Economic Commission for Europe**Inland Transport Committee****Working Party on Intermodal Transport and Logistics****Sixty-fifth session**

Code of Practice for Packing of Cargo Transport Units**Code of Practice for Packing Cargo Transport Units – text prioritized in updates: transport stability level, bedding arrangements, load distribution, stabilizers and other changes****Note by the secretariat****I. Introduction**

Figure 7.35: Marking of Transport Stability Level 4 in both length (L) and width (W) directions.

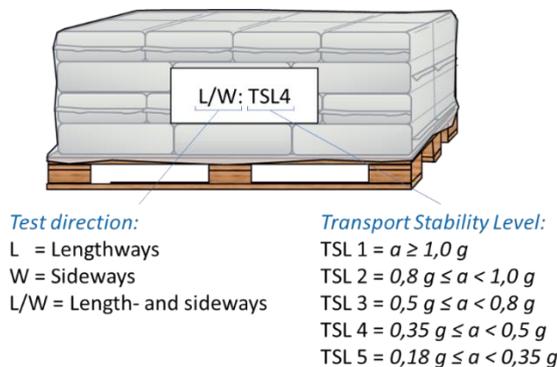
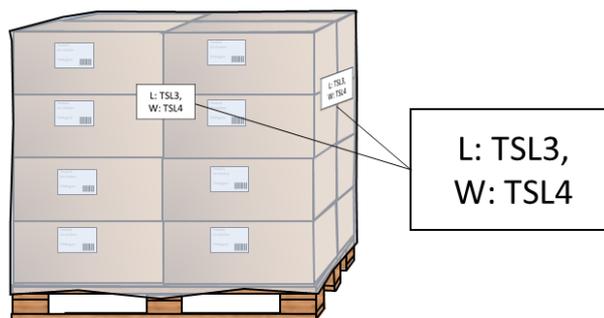
It is possible that test results for TSL differ in different directions depending on the shape of the package and therefore the lowest value for length and width directions should be displayed as per examples below (see figures 7.35 and 7.36).

Figure 7.37: A package marked with TSL 3 or better may be bottom blocked sideways during road transport, while a package marked with TSL 4 risk collapsing in this situation.

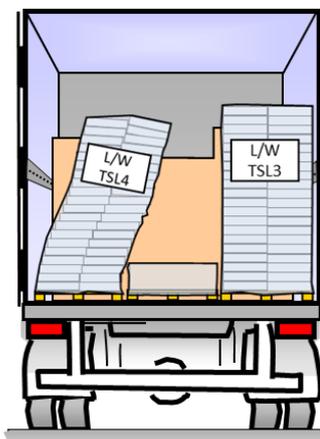
If the value of the directional TSL for a package (see table 7.8) is equal to or exceeds the directional acceleration coefficients (see chapter 5) for the intended transport mode, bottom blocking should be sufficient to prevent the cargo from sliding. When using bottom blocking only, table 7.9 below indicates the lowest required TSL to secure cargo in different directions and different modes of transport (see figure 7.37).

Figure 7.38: During transport in a road vehicle complying with standard EN 12462-XL, packages marked with TSL 4 or better may be secured by blocking against the CTU's sides only, whilst packages marked with TSL 5 needs additional securing measures, e.g. top-over lashings.

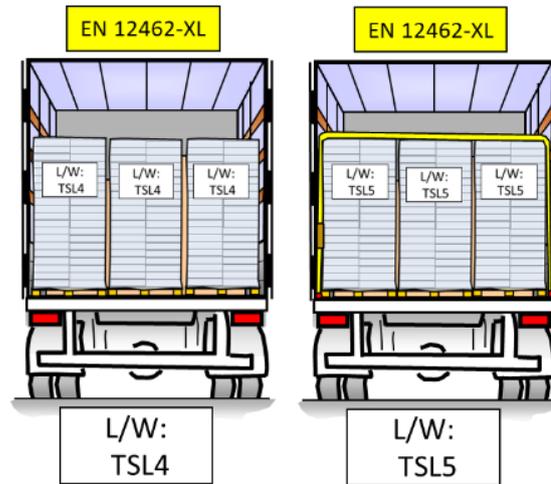
The TSL of the package indicates if the strength of the boundaries of the CTU is sufficient for blocking the packages or if additional securing methods are required by other means, e.g. lashings, in order not to overstress the CTU's boundary walls (see table 7.10 and figure 7.38). The lowest required TSL to block the cargo against the boundary walls of the CTU (evenly distributed cargo)

Figure 7.6398

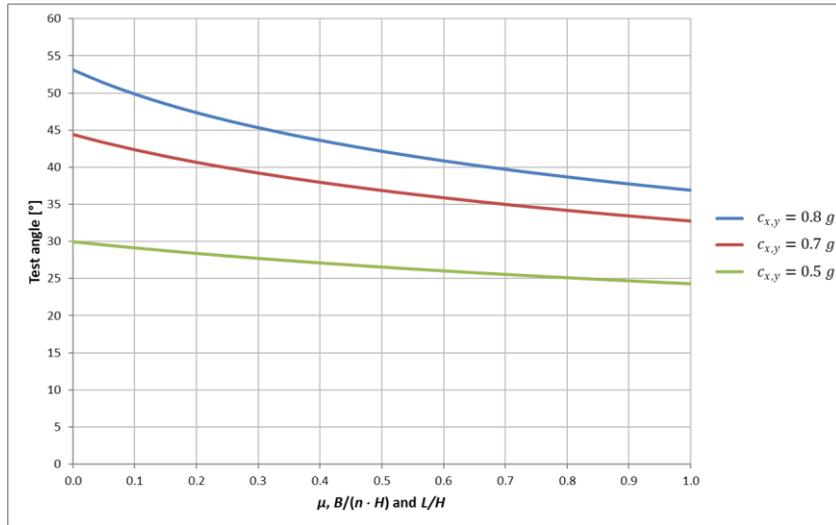
If μ and $\frac{B}{n \cdot H}$ is 0.3 at for sideways accelerations sideways at in transport in sea area B ($c_y = 0.7 \text{ g}$) the cargo securing arrangement should be able to be inclined to approximately 39° , according to the diagram figure 7.98 and table 7.15

Figure 7.101

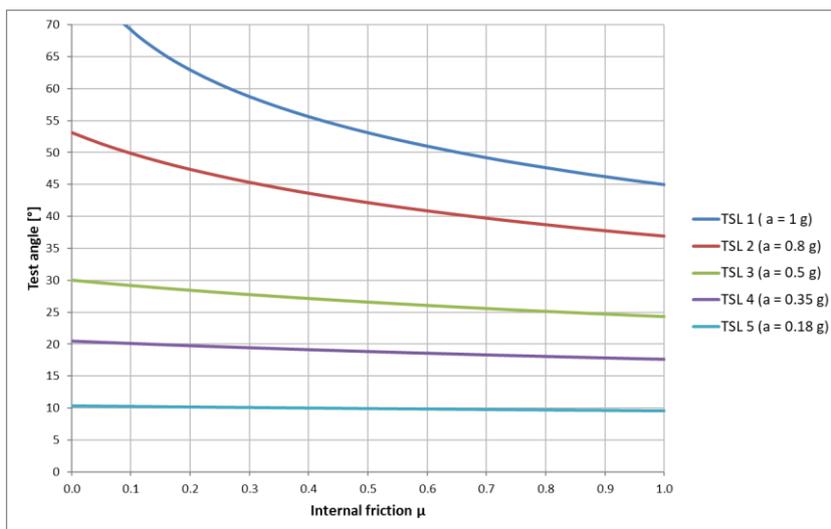
6.1 The required test angle α as a function of chosen TSL (1 – 5) is taken from the diagram shown in figure 7.101 or from the table 7.16 below.

If the internal friction of a package is determined to $\mu = 0.40$ and transport stability level chosen to be tested is TSL 3 the package should be able to be inclined to approximately 27°, according to the diagram

Figure 7.27 Minimum length

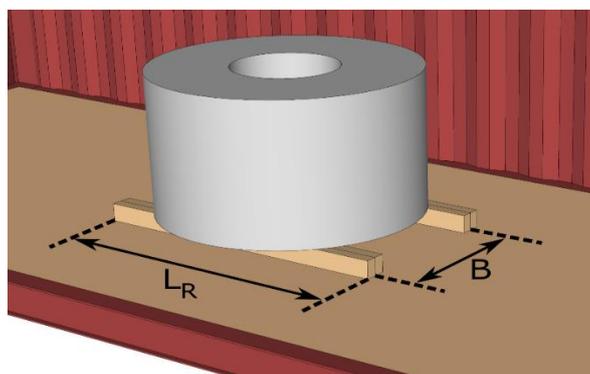
1. The bedding beams must be long enough to cover the distance of the container's floor so that load from the cargo will not overstress the floor.
2. The minimum length depends on the following factors (see figure 7.27):
 - The cargo mass (in tonnes)
 - The spacing of the beams, B (in meters)

Figure 7.28 Minimum dimensions

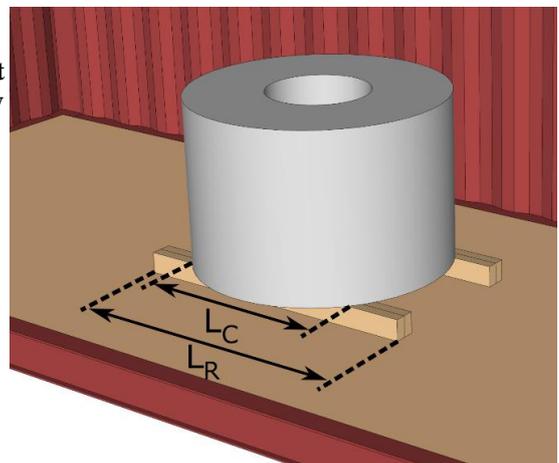
1. The proper size of the bedding beams depends on the bending resistance (section modulus) that is required of the beams for them to successfully transfer the load from the cargo over the required floor length. The required section modulus depends on the following factors (see figure 7.28):

- The cargo mass (in tonnes)
- The minimum length of the beams, L_R (in meters), as given by table below
- The length of the footprint of the cargo on the beams, L_C (in meters)
- The strength of the material of the bending beams

Figure 7.323 An example of a load distribution diagram for a semi-trailer

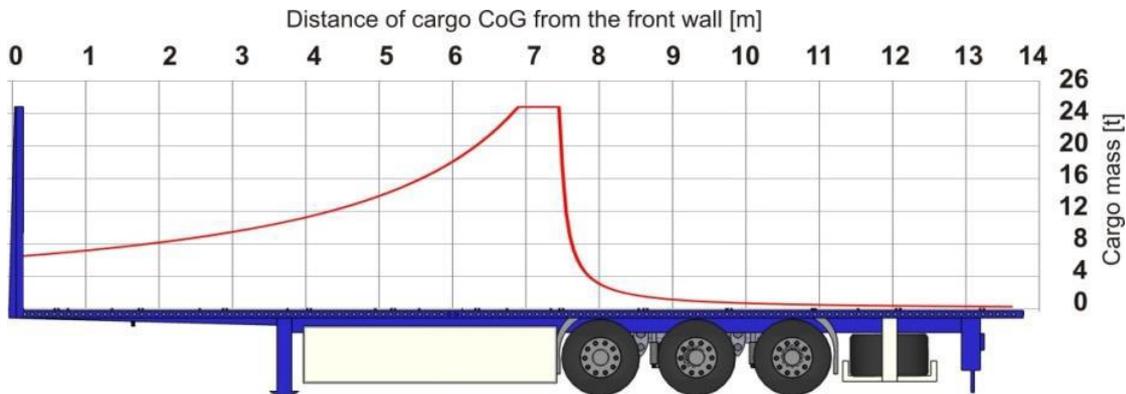
~~3.3.53.1.7~~ Road trucks and road trailers are in particular sensitive regarding the position of the centre of gravity of the cargo packed in them, due to **the manufacturer's** specified axle loads for maintaining steering and braking ability **as well as the infrastructure's**

restrictions for vehicle gross mass as well as axle and bogie loads. In case of semi-trailers, the maximum king pin load, resulting from the towing trucks restrictions, must also be considered. Such Individual vehicles may be equipped with specific load distribution diagrams, which show the permissible cargo mass as a function of the longitudinal position of its centre of gravity. Generally, the maximum cargo mass payload may be used only when the centre of gravity (CoG) is positioned within narrow boundaries about half the length of the loading space (see figures 7.22 and 7.323).

Figure 7.34 An example of a combined load distribution diagram for the handling and capacity of a 40-foot container as well as transport on a two-axle rail wagon

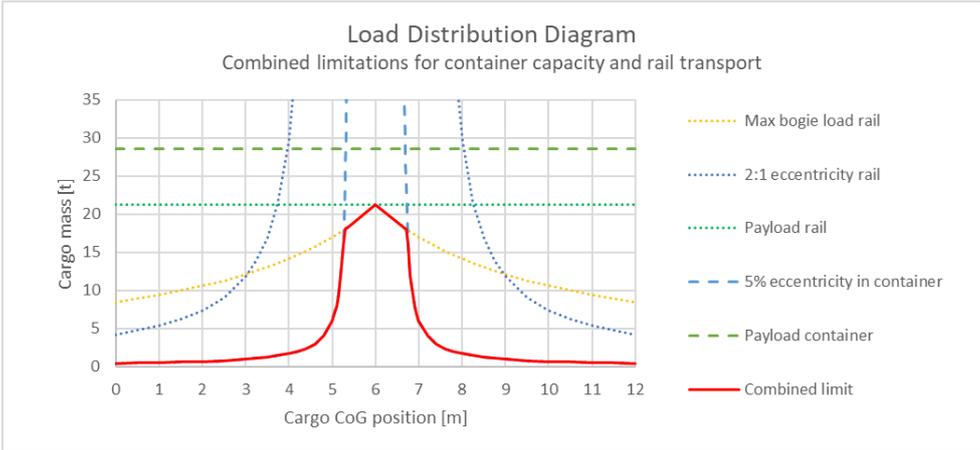
3.3.7 Load Distribution Diagrams for different modes of transport may be superimposed to show the combined limiting curve for the whole intended voyage, as illustrated in the example in figure 7.34.
